**WEST HAVEN CITY
PLANNING COMMISSION AGENDA**

November 10, 2021 6:00 P.M.
City Council Chambers
4150 South 3900 West, West Haven, UT 84401

Planning Commission Staff Review Memo

SHEET 1 OF 1

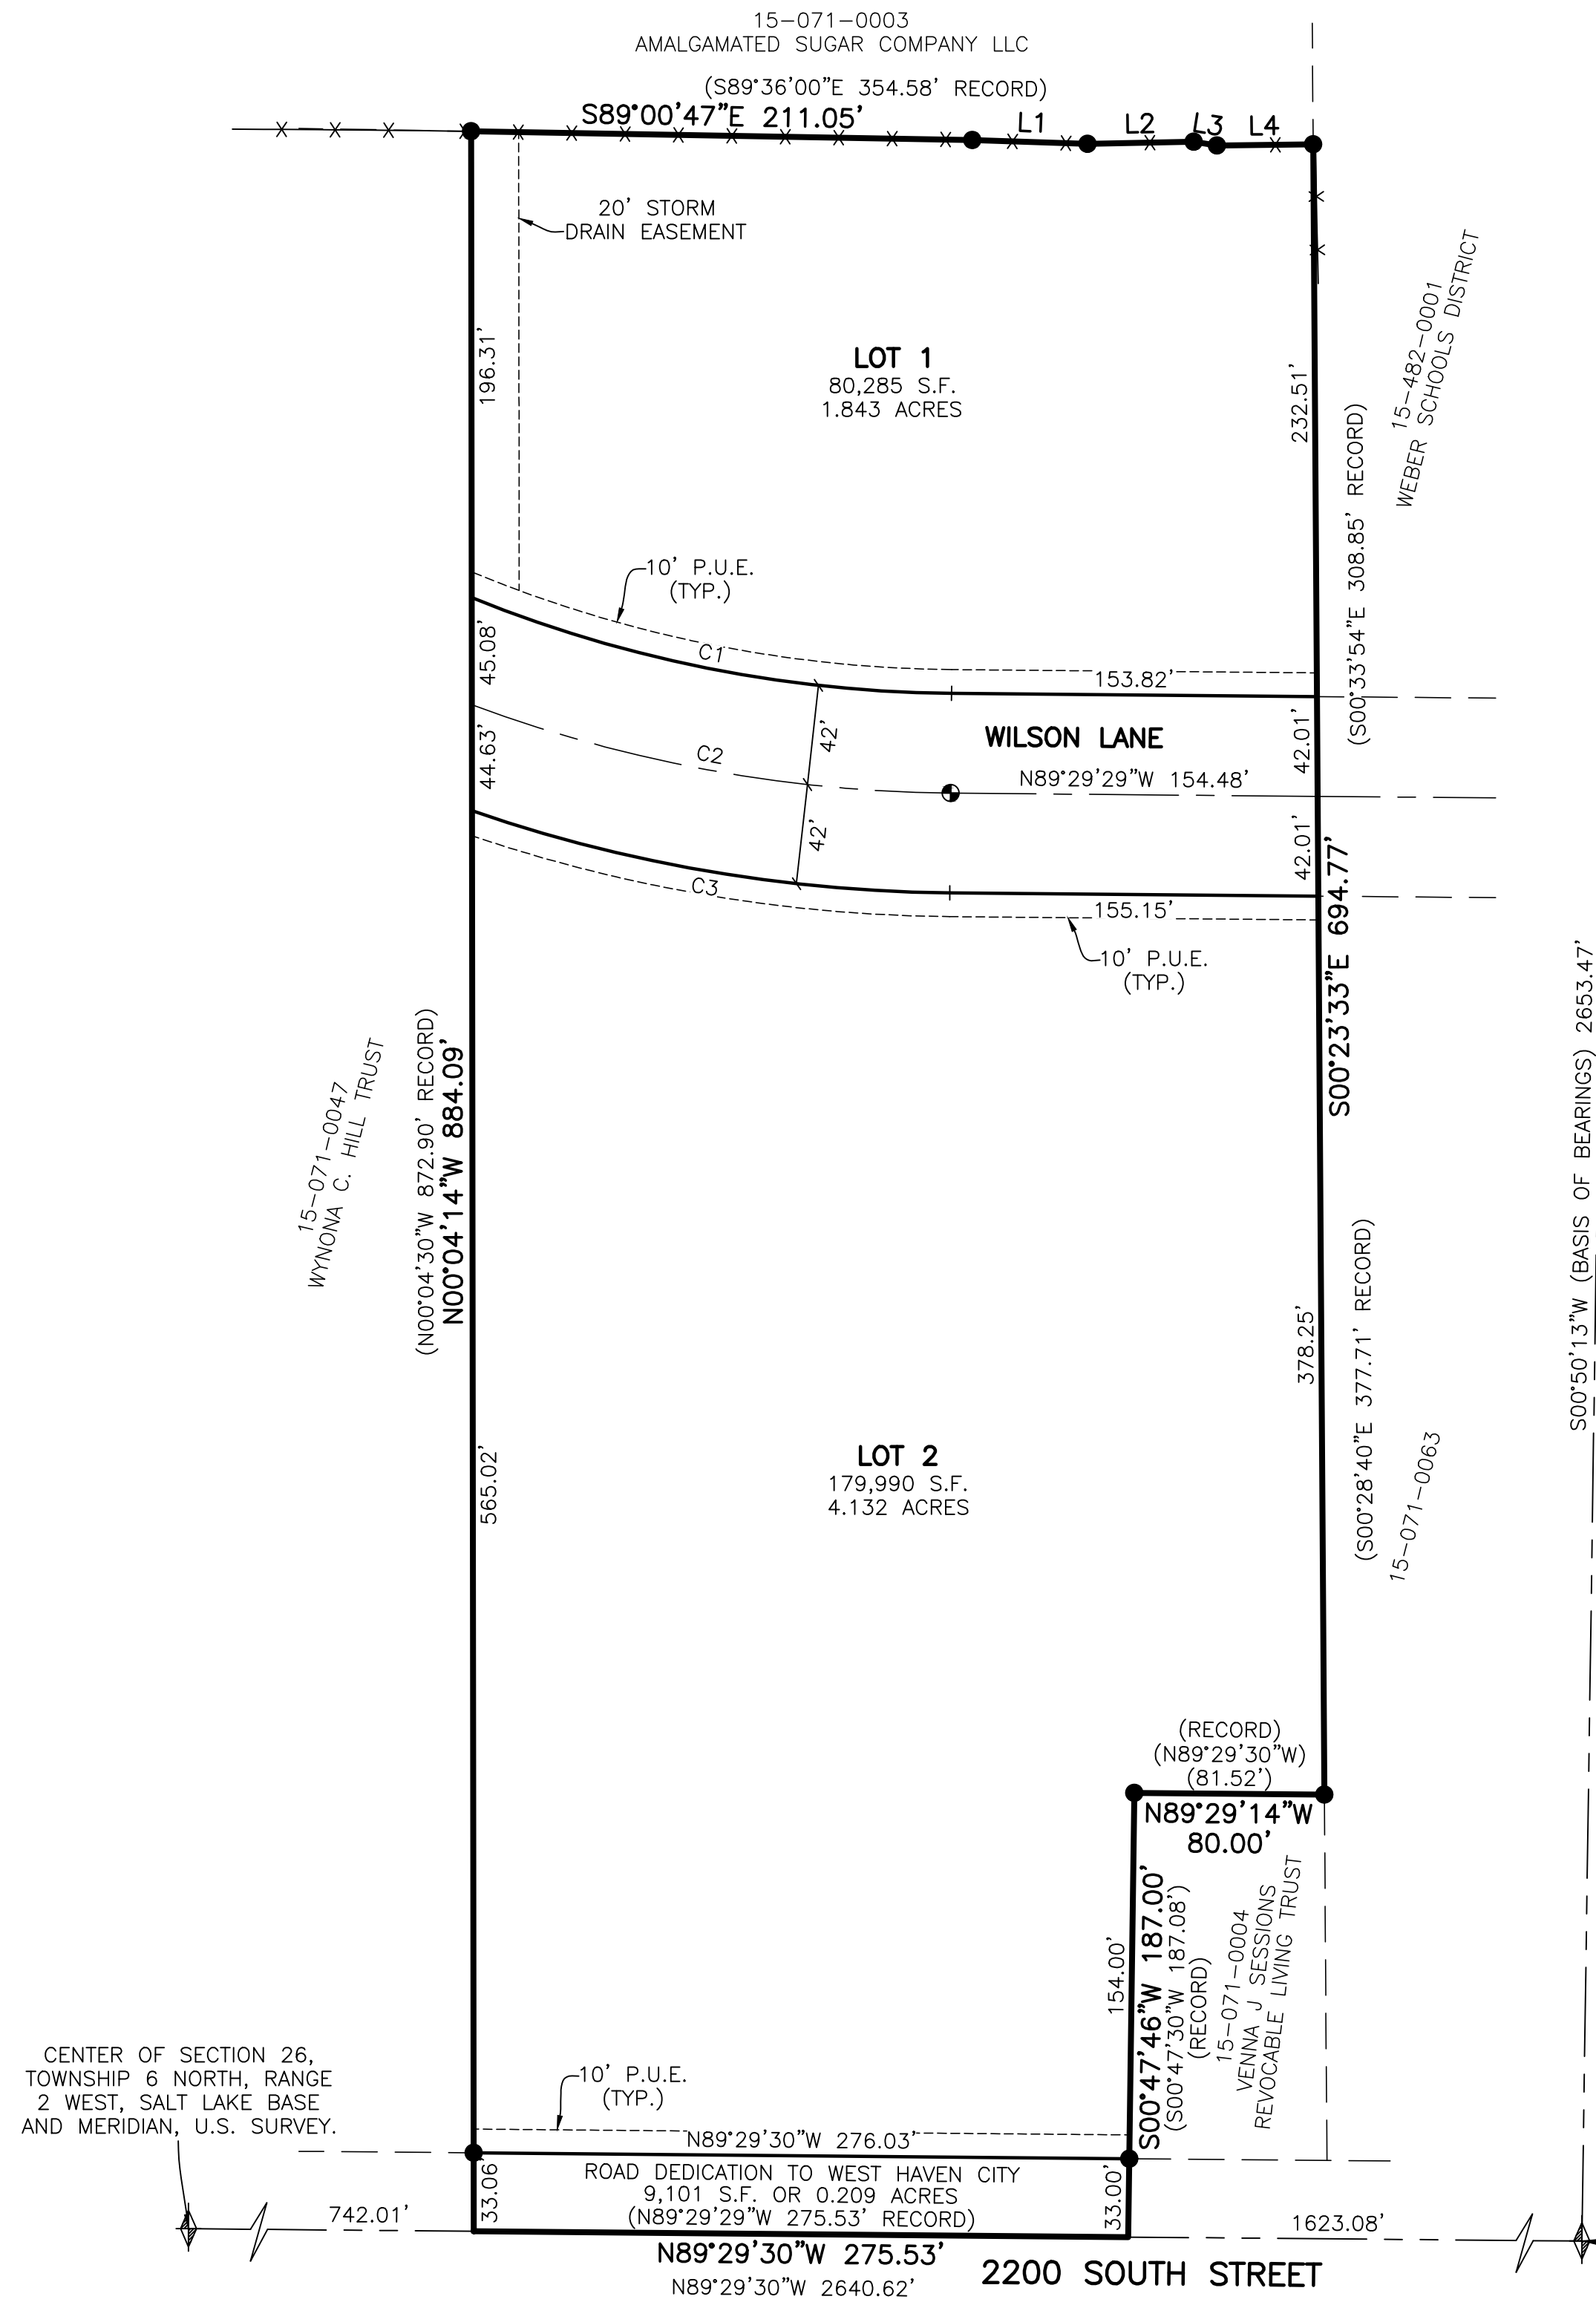
As the property is zoned Commercial C-2, there are no minimum lot areas or widths that the developer needs to meet, nor is there a density standard to evaluate. The proposed location and width of Wilson Lane (2100 South west of 1900 West) complies with what is in place and what this will tie into. They will need to provide a temporary turnaround where the property dead ends into the Hill property.

As it is compliant with the requirements of relevant City code, staff recommends the final plat be approved, subject to the following condition:

- Prior to recording the mylar in the office of the Weber County Recorder, developer shall be required to obtain approval of the City Engineer, as well as any relevant special service districts, regarding infrastructure improvements on the property relevant to their areas of jurisdiction.
- Developer shall be required to coordinate placement and width of a temporary turnaround with the Weber Fire District.

WEBER WEST PUMP STATION
WEBER BASIN CONSERVANCY DISTRICT
WEST HAVEN, UTAH
BUILDING ELEVATIONS

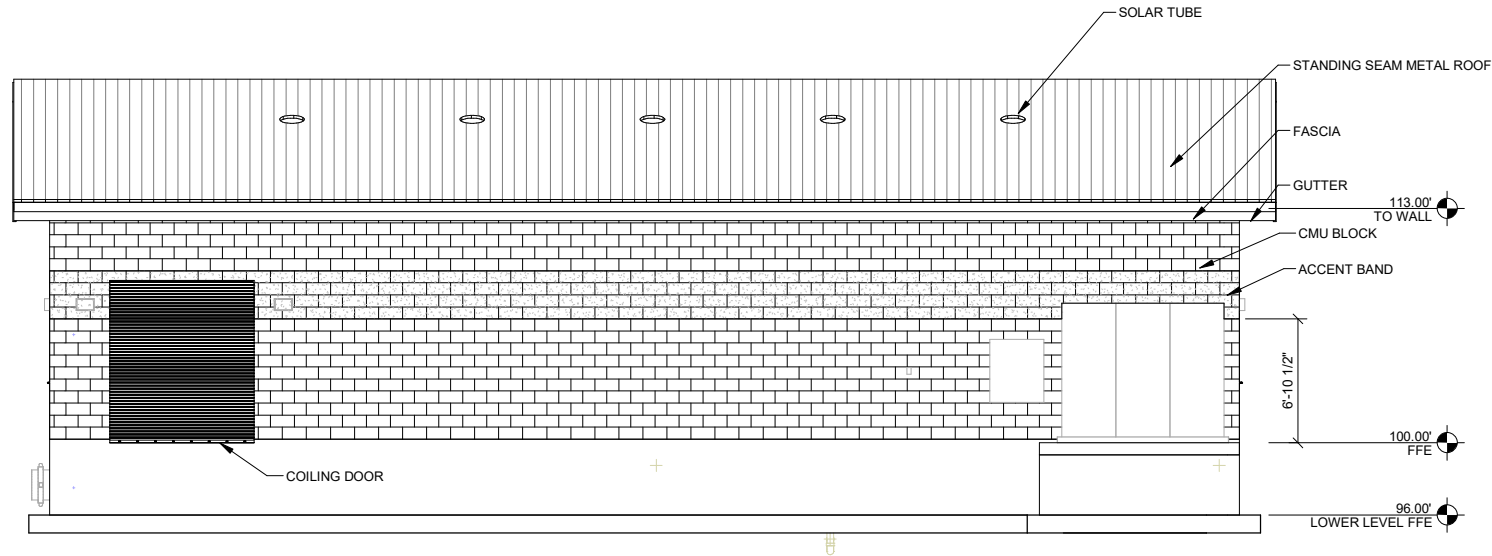
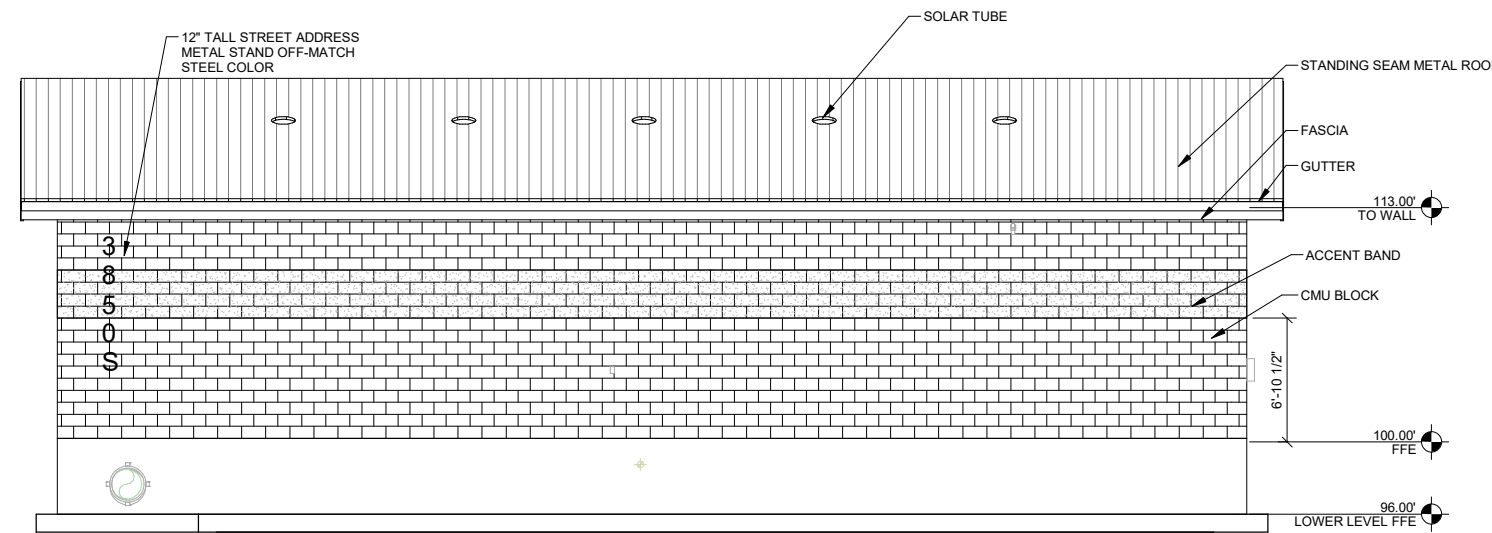
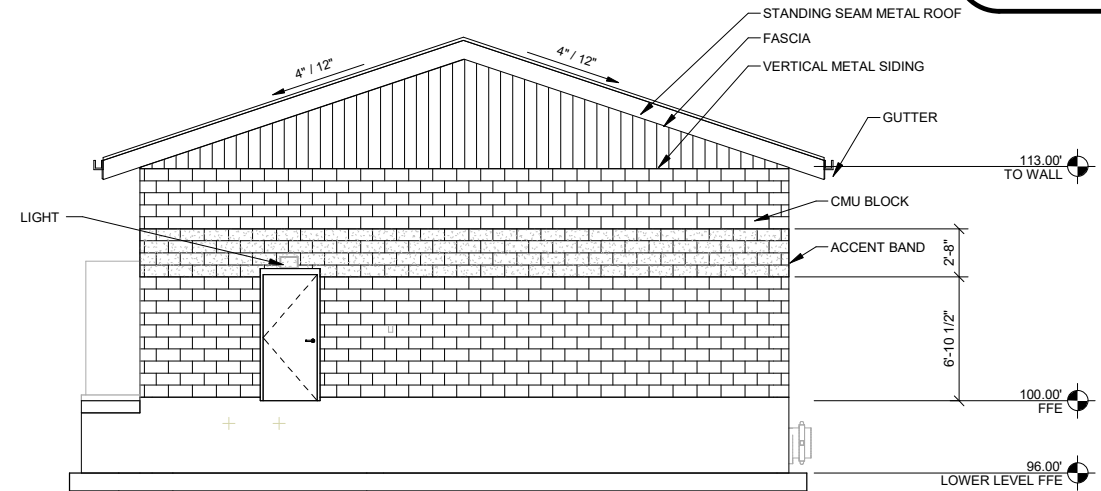
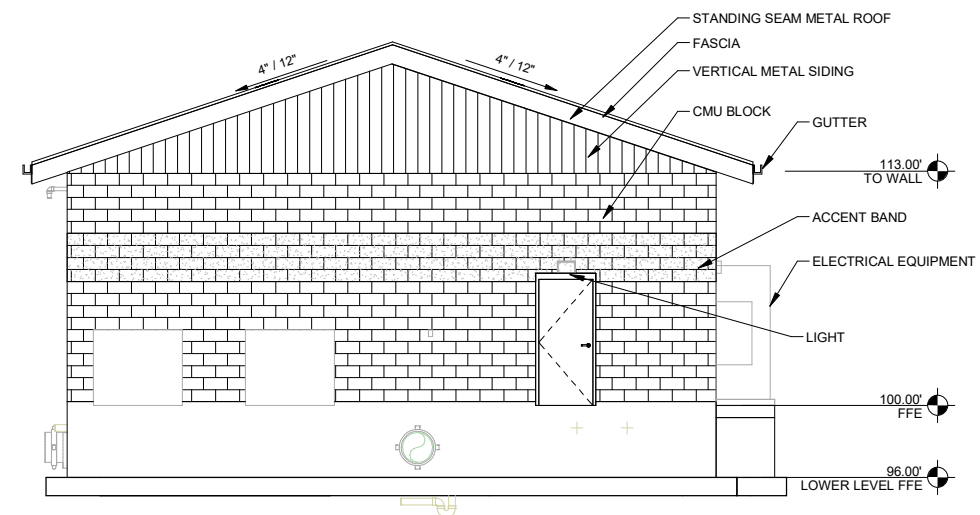
1. ***See previous comment. The pattern continues all the way around, meeting the upgraded feature requirement.***

1. ***This requirement does not apply, as this is not part of a planned development.***

WESTWOOD ESTATES SUBDIVISION PHASE 1

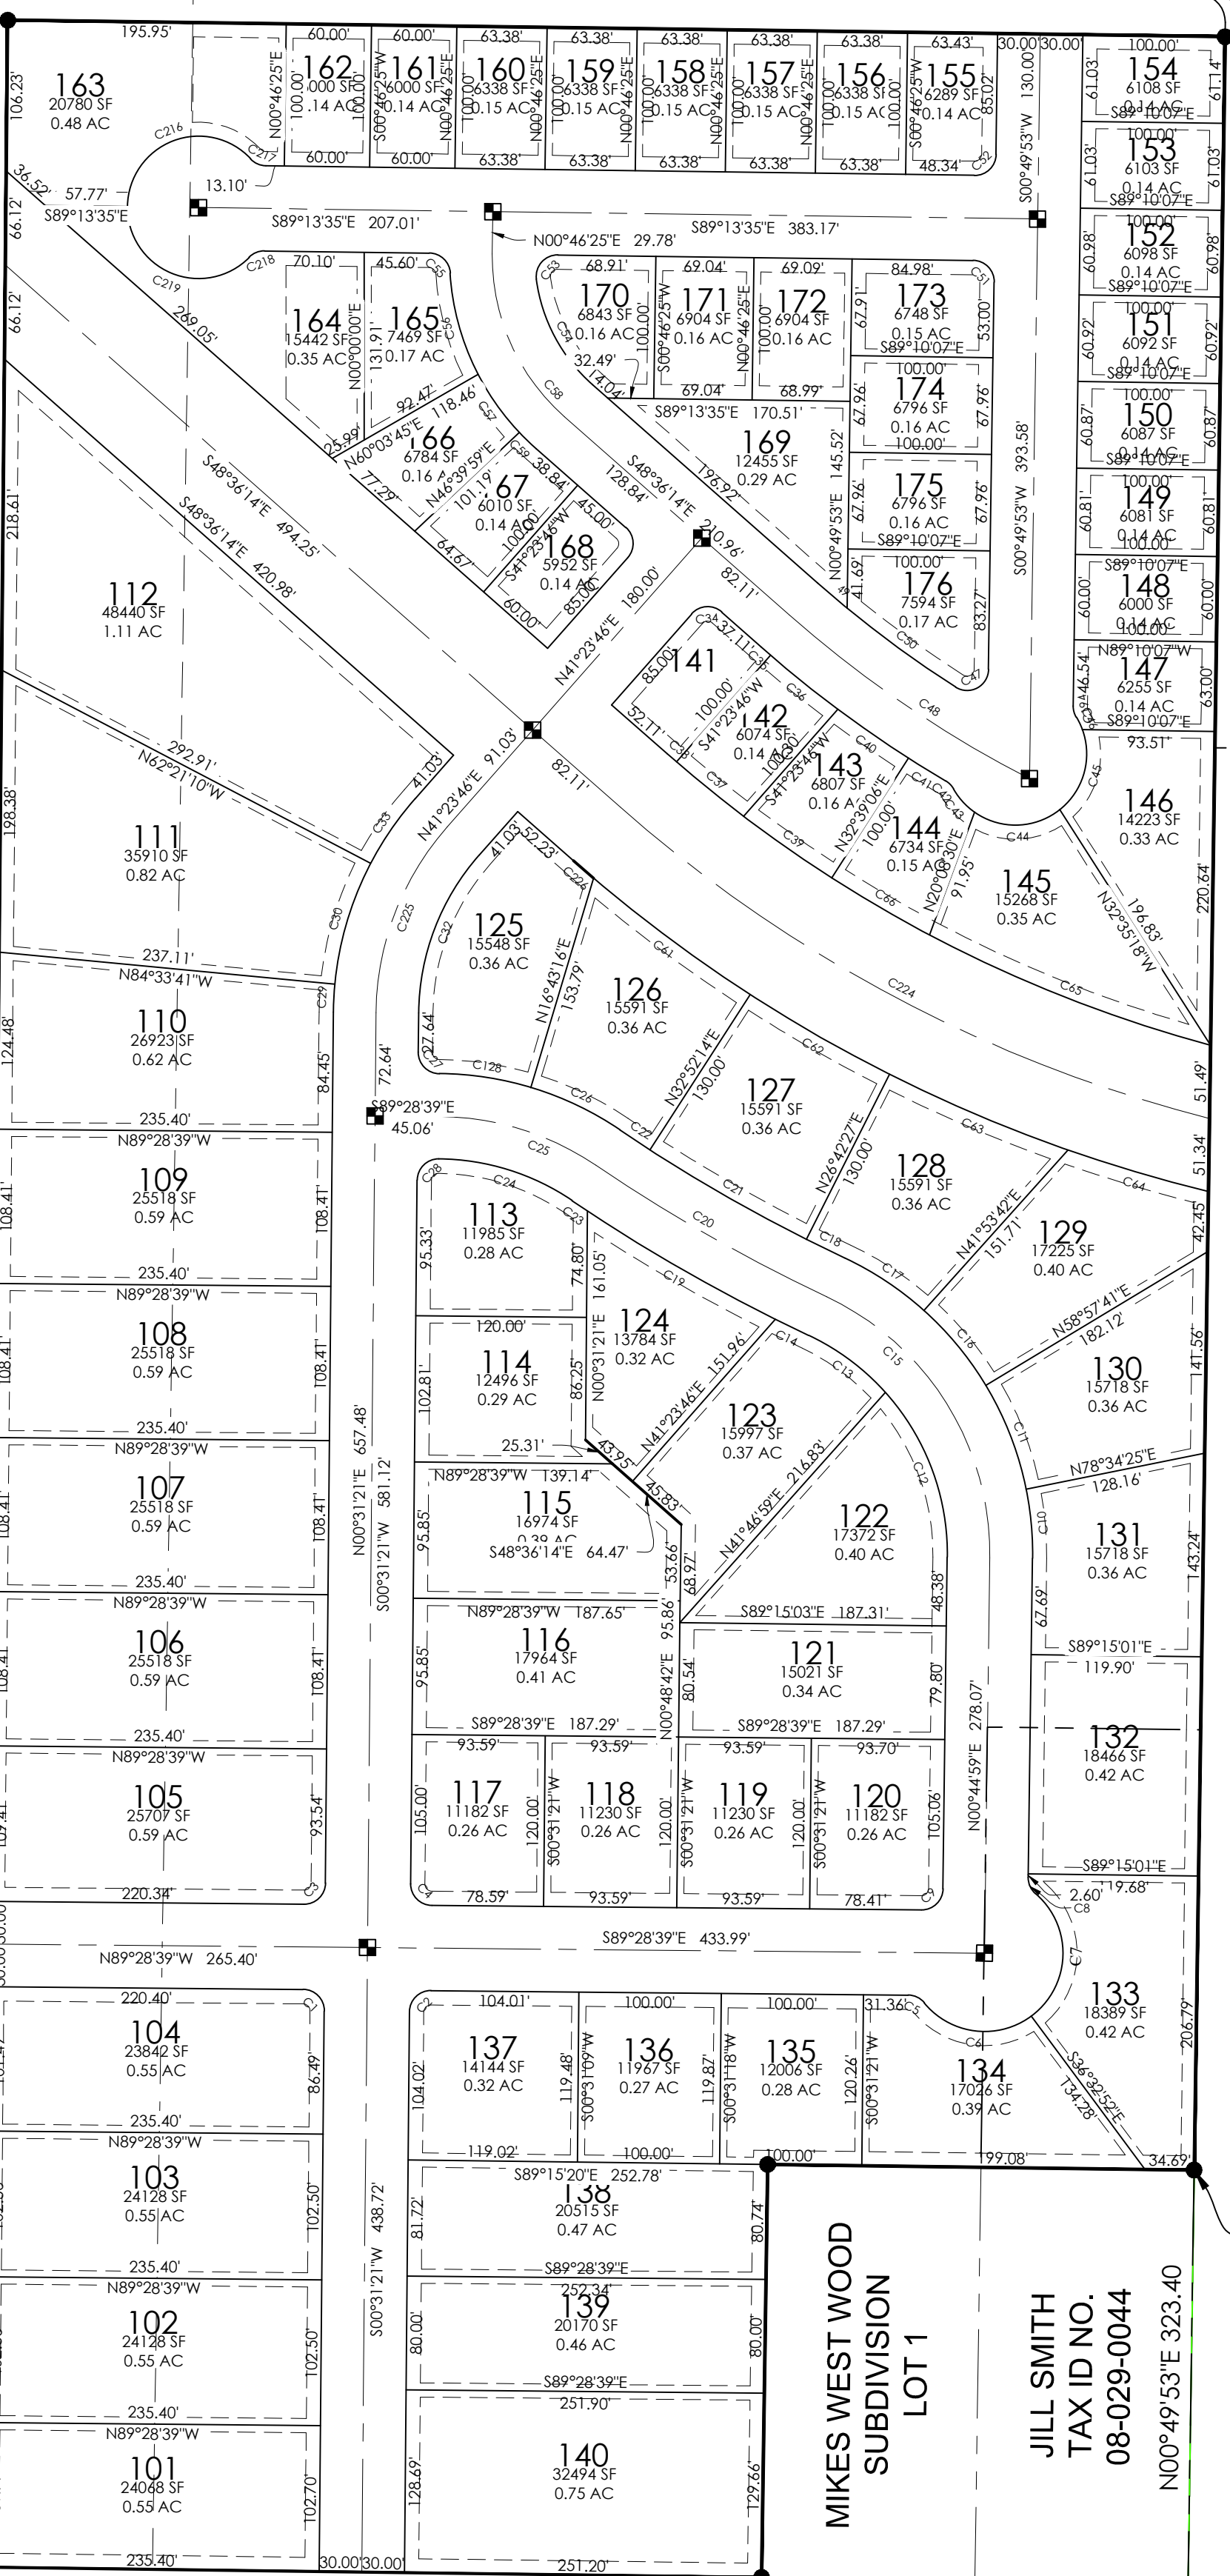
I do have some safety concerns about lots accessing the future ROW or 3600 South, which will eventually be expanded. I would recommend that the Commission put a condition in place that no lots may have driveway access on to either of those right-of-ways.

Staff recommends that the Commission grant final approval to Westwood Estates subdivision, Phases 1, 2a, 2b and 3, with the condition that no lots may have access on to the future 80' ROW or onto 3600 South.
